ANN ARBOR HISTORIC DISTRICT COMMISSION

Staff Report

ADDRESS: 1034 W Liberty Street Application Number HDC24-0004

APPLICATION: The applicant seeks HDC approval to add a two-story rear addition with a walkout basement, a rear deck, and three skylights on the addition's roof.

PROPOSED NORTH ELEVATION

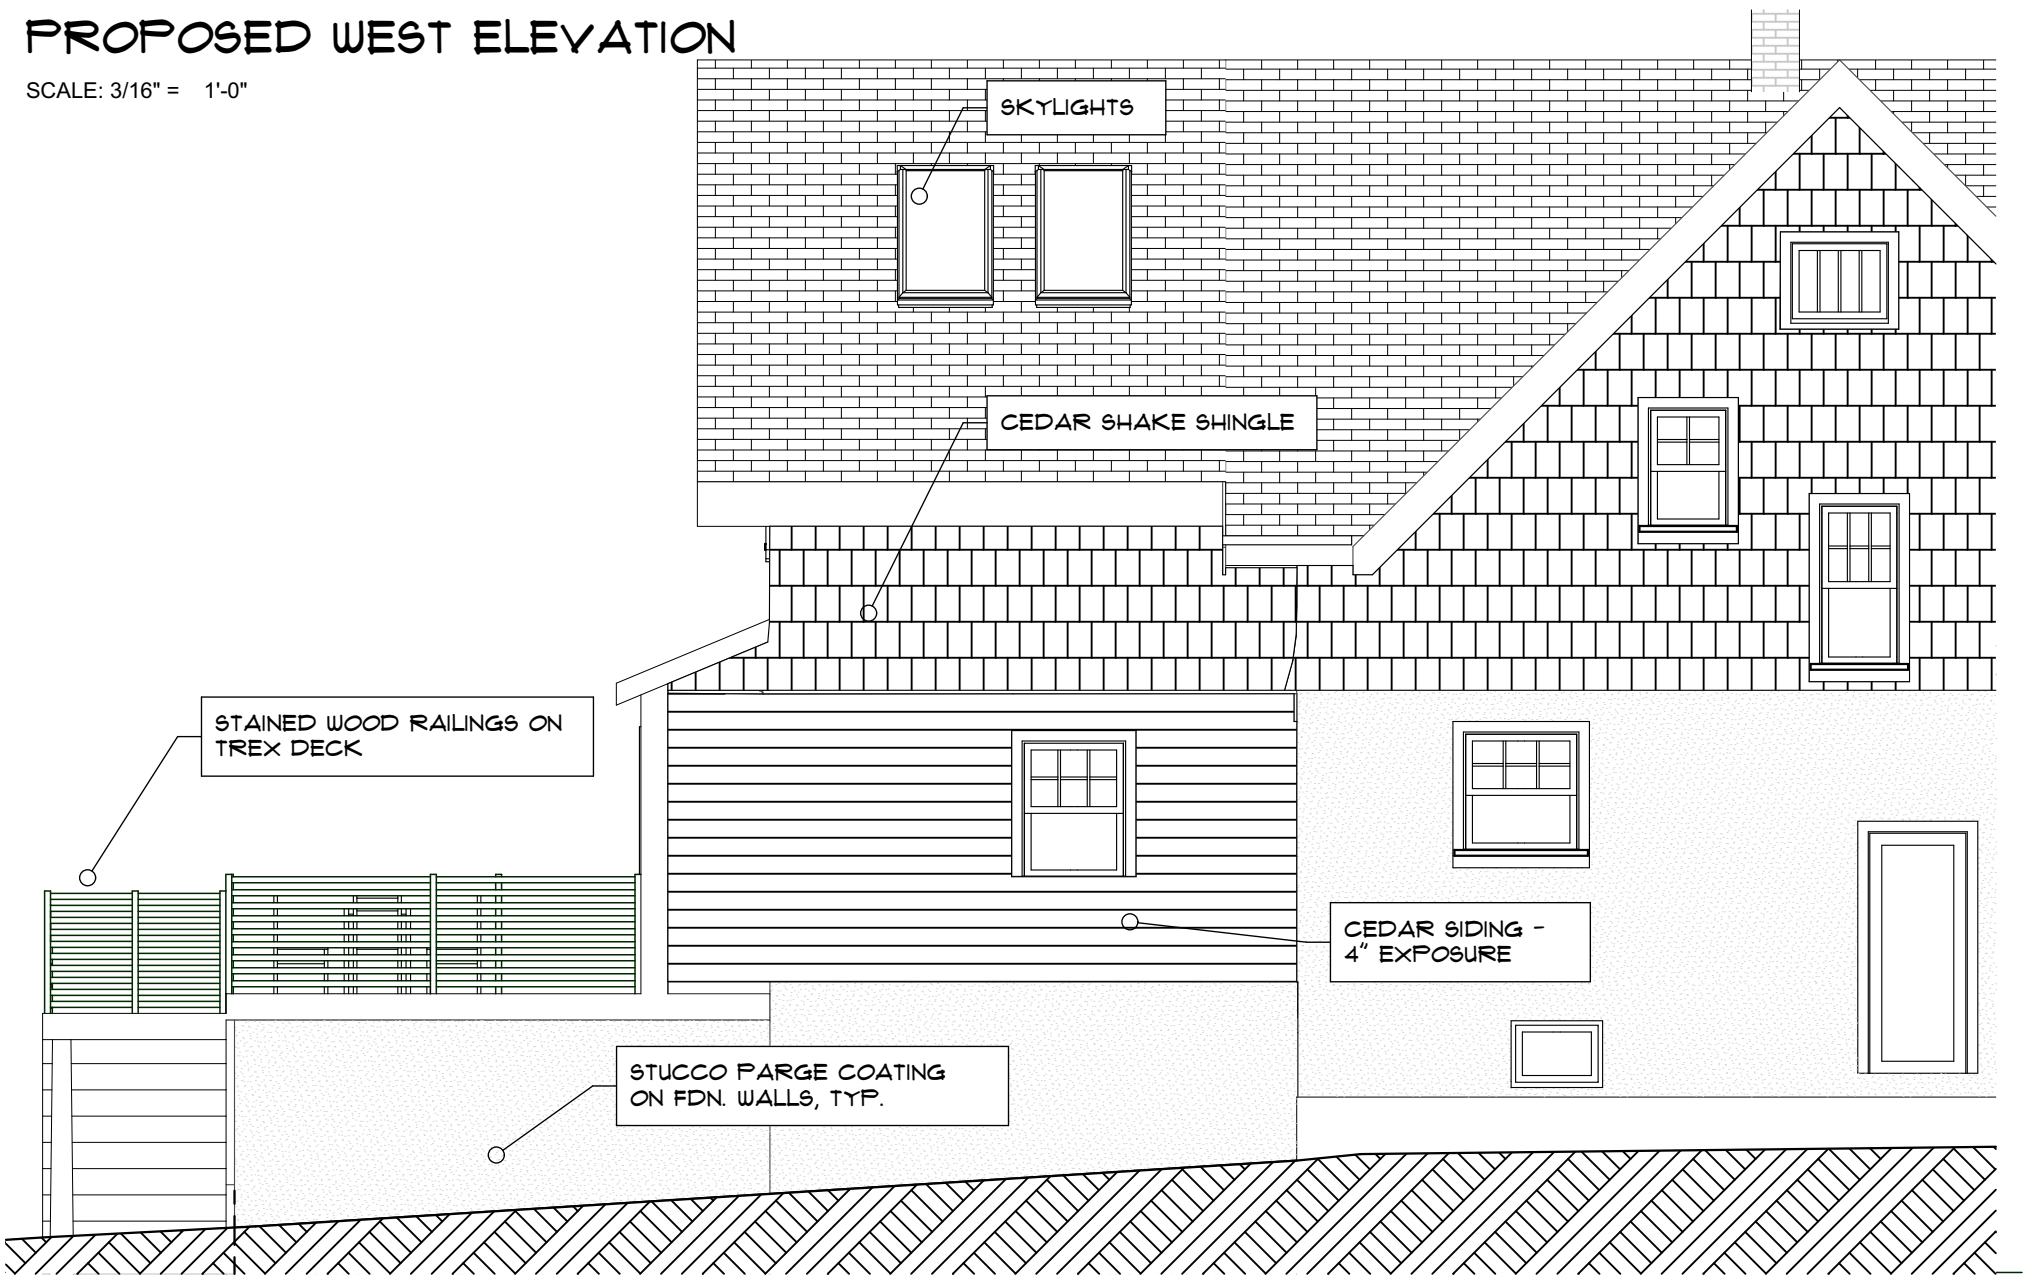
4. The roof between the historic house and addition is differentiated at the eaves, but the ridge is not lower than the current ridge, as is often required to differentiate the addition. Since the house is 1 3/4 stories there is likely a headroom issue on the interior of the addition. At the meeting the applicant or architect should be prepared to describe why the addition's ridge wasn't dropped below the barge board on the rear-facing gable.
